RE: Modification to the Nos. 4 Combination Boiler, Lime Kiln and Recovery Boiler
Project No.: 1070005-038-AC/PSD-FL-380

On August 18, 2006, GP received a Request for Additional Information (RAI). Our responses to your questions and comments are presented in this letter. In preparing this response, we were very disappointed to find that many of the questions and comments had nothing to do with the permit applications at issue, but instead were asking the Mill to substantiate and defend data and assumptions that were part of past air permitting actions where final permits have long since been issued. This greatly added to the time that it took for us to prepare this response and we are concerned that this action will further delay issuance of our final permit. Furthermore, we strongly believe that data and facts reviewed in prior applications that resulted in a permit being issued should be stipulated as already having been approved by the Department and not subject to further review. Questions No. 1-3 and 5-8 fall into this category.

Updated Process Flow Diagram – No. 4 CB – (GP-EU1-11)

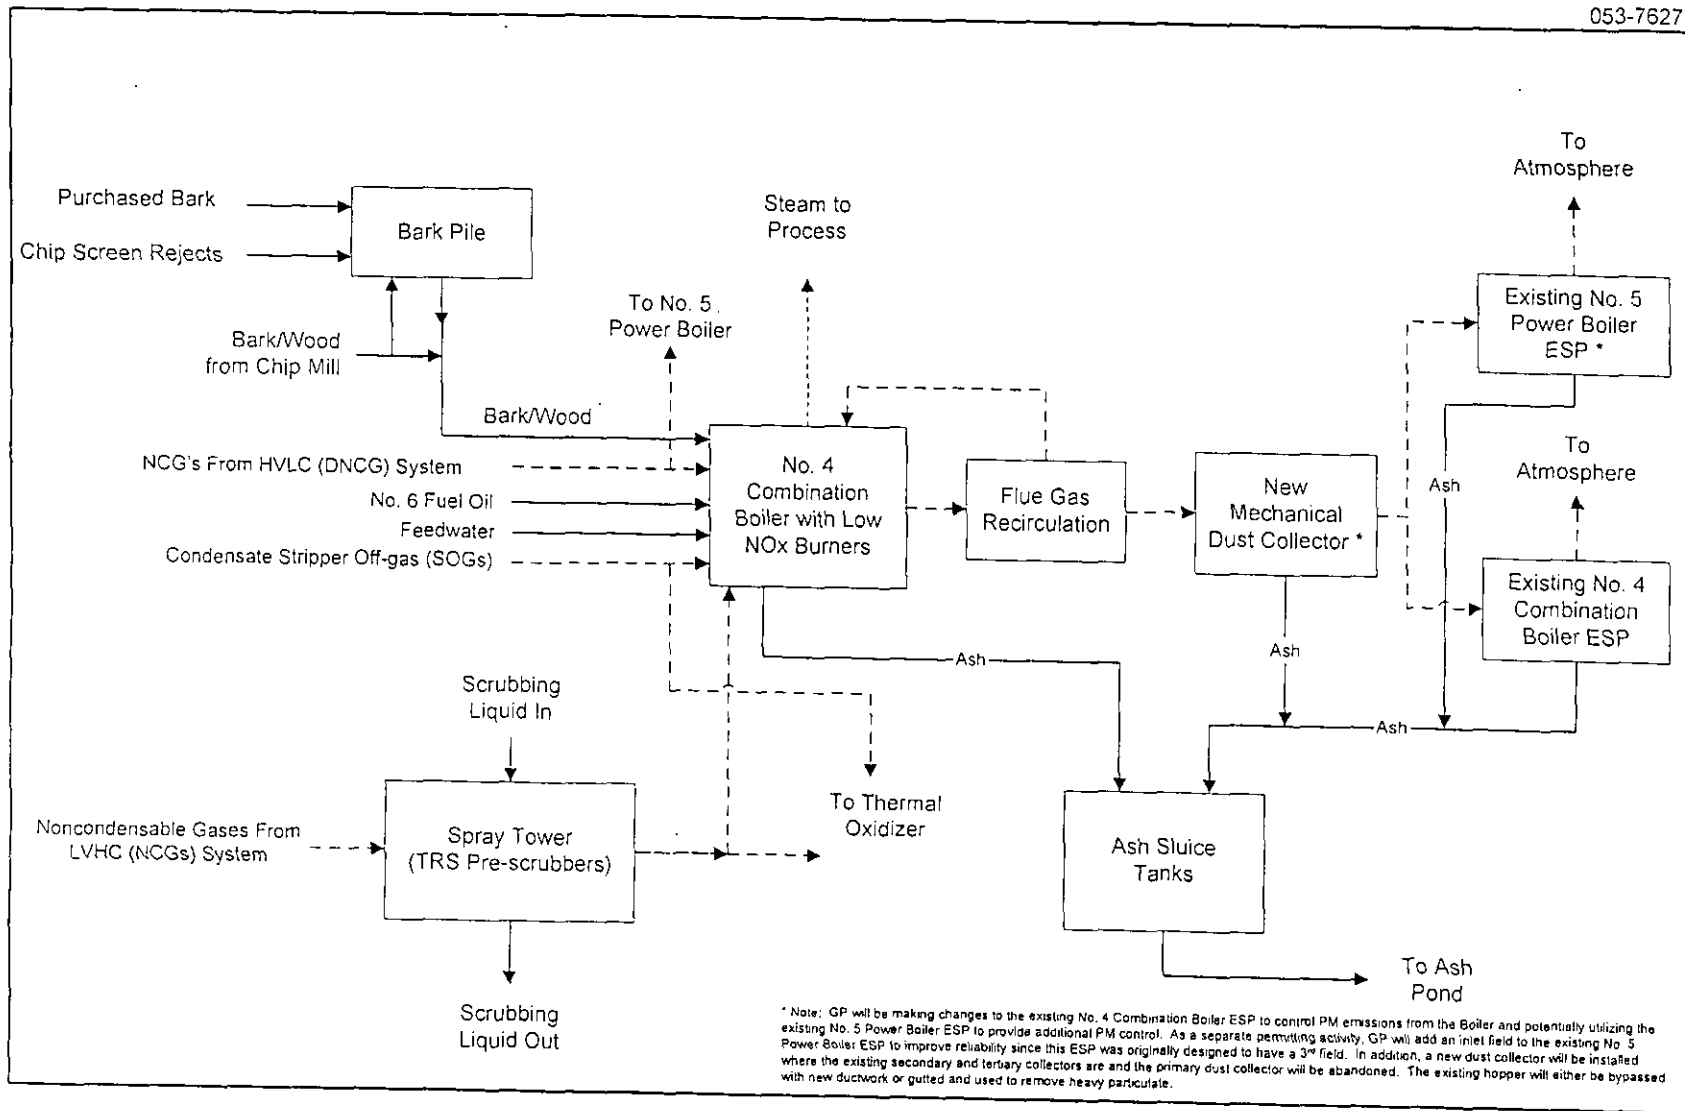
13. See Attachment GP-EU1-II, which is a process flow diagram for the No. 4 CB.

a. This chart shows ash from the new mechanical dust collector being directed back to the NO. 4 CB and not the ash sluice tanks. Please explain.

Ash from the dust collectors and precipitators will be sluiced. An updated Process Flow Diagram is included in Attachment C.
